**Hitachi-GE Nuclear Energy, Ltd.**  
**UK ABWR GENERIC DESIGN ASSESSMENT**  
**Resolution Plan for RO-ABWR-0034**

**Demonstrating the inclusion of a 'bottom drain line' in the UK ABWR design achieves inherent safety and reduces risks SFAIRP**

<b>RO TITLE:</b>	Demonstrating the inclusion of a 'bottom drain line' in the UK ABWR design achieves inherent safety and reduces risks SFAIRP	
<b>REVISION :</b>	<u>1</u>	
<b>Overall RO Closure Date (Planned):</b>	31 <u>March</u> 2017	
<b>REFERENCE DOCUMENTATION RELATED TO REGULATORY OBSERVATION</b>		
<b>Regulatory Queries</b>	RQ-ABWR-0082	
<b>Linked ROs</b>	-	
<b>Other Documentation</b>	-

**Figure 1: Depiction of the CUW for UK ABWR [Ref-0-3]**

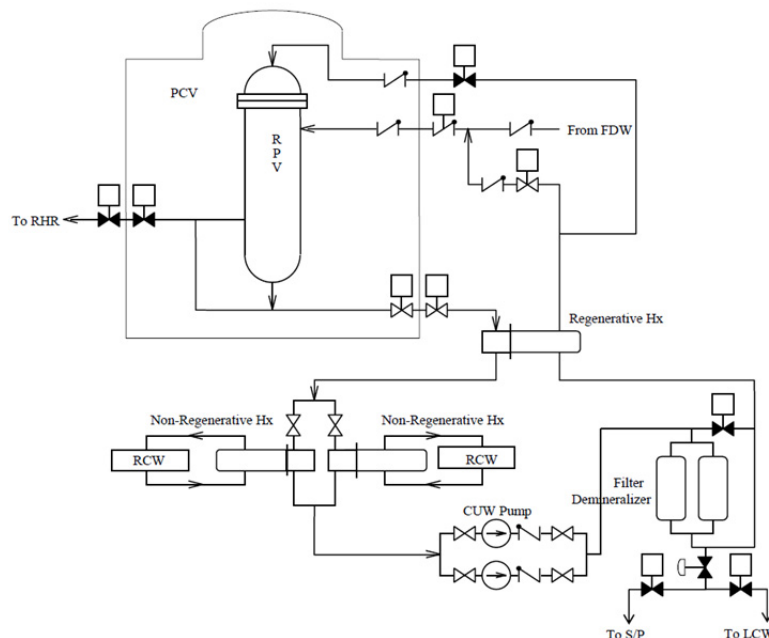
The UK ABWR currently includes a design feature referred to as the 'bottom drain line'. The line is located at the bottom of the RPV and is connected to the CUW, as depicted in Figure 1 below as the line appearing as an arrow at the bottom of the RPV:

- What the function(s) of the ‘bottom drain line’ in the UK ABWR design is(are), and based on their response to question 1, to provide:
- A justification that the presence of a ‘bottom drain line’ in the UK ABWR design reduces risks SFAIRP.

The reason for this RQ was that ONR understood that the drain line is a significant contributor to operator dose during outages, and at that time Hitachi-GE were considering material changes to this line as a measure to mitigate the dose.

ONR has subsequently undertaken further assessment work related to this aspect of the design, the outcome of which confirms that such features are significant sources of dose and also challenges the reasons originally put forward for the inclusion of the ‘bottom drain line’ for UK ABWR. In summary, ONR has found that:

- a. All German Boiling Water Reactors (BWRs) have permanently closed the drain openings at the RPV bottom [Ref-0-4];
- b. All Swedish BWRs that were originally designed with a ‘bottom drain line’ have now permanently closed them, principally because;

- Operating Experience Feedback (OPEX) has shown the line was not required in practice and was a large contributor to worker dose uptake during the outage;

- The line was originally intended to drain CRUD (Chalk River Un-identified Deposit) which may accumulate in the bottom of the RPV, but OPEX showed CRUD accumulation did not prove problematic [Ref-0-5].

- c. The design of all Swedish internally pumped BWR plants (similar to the UK ABWR design) does not include a ‘bottom drain line’ [Ref-0-5];
- d. Some BWRs in the United States of America (USA) have also permanently closed the drain openings at the RPV bottom;

This RO has therefore been raised to make clear ONR’s expectations regarding Hitachi-GE’s justification for the inclusion of a ‘bottom drain line’ in the UK ABWR, specifically whether this achieves an inherently safe design which avoids radiological hazards rather than controlling them, and whether its presence reduces risks SFAIRP.

The current ALARP justification document [Ref-1-3] describes the BDL related functions within the constraints of the current design (i.e. with the BDL in place). Hitachi-GE will undertake additional activities to underpin the ALARP study for the BD, such as, a review of the functions, the links to the High level Claims and links to other disciplines in GDA.

Hitachi-GE will review and confirm the criteria or risk indicator used to undertake the BDL ALARP study to ensure it is comprehensive and consistent with the Hitachi-GE ALARP methodology document [Ref-1-5].

Hitachi-GE will undertake a further review of Worldwide OPEX in order to ensure all design options are included within the study. Although the majority of BWRs in the world have a BDL, Hitachi-GE is aware that BWRs without a BDL exist in Europe (e.g. Sweden) Hitachi-GE will include these alternate options within the ALARP study.

On the basis that new and revised information will have been developed in RA1 to 3, the optioneering study will be revisited in order to ensure all aspects (e.g. functions and design options) are considered.

Following the options study, the chosen design option will be reviewed to confirm overall risks has been reduced SFAIRP with a comparison to Worldwide OPEX.
